Table 1.6-2 Material Referenced as Technical Reports (Sheet 2 of 5)

Table 1.6-2 Material Referenced as Technical Reports (Sheet 3 of 5)

MIC-04-09-
00008**Figure 9.1.2-2 Spent Fuel Rack Array**

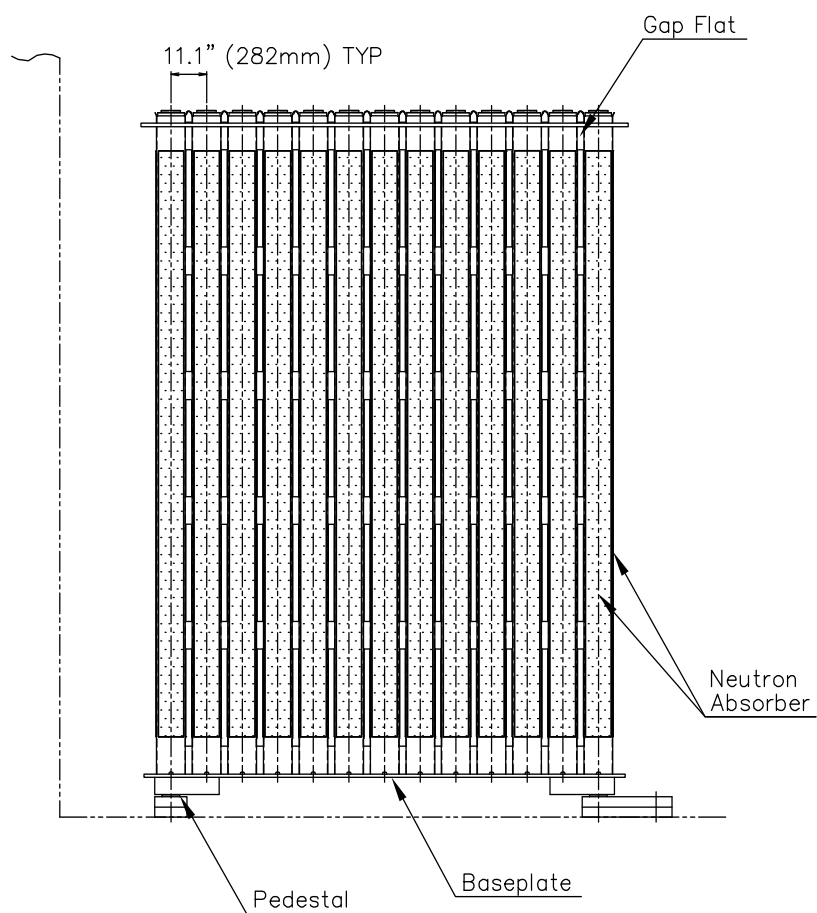
Moderate density racks containing a neutron absorber material are provided in the SFP. Center-to-center spacing of the rack array is 11.1 inches to maintain the required degree of subcriticality as shown in Figure 9.1.2-2.
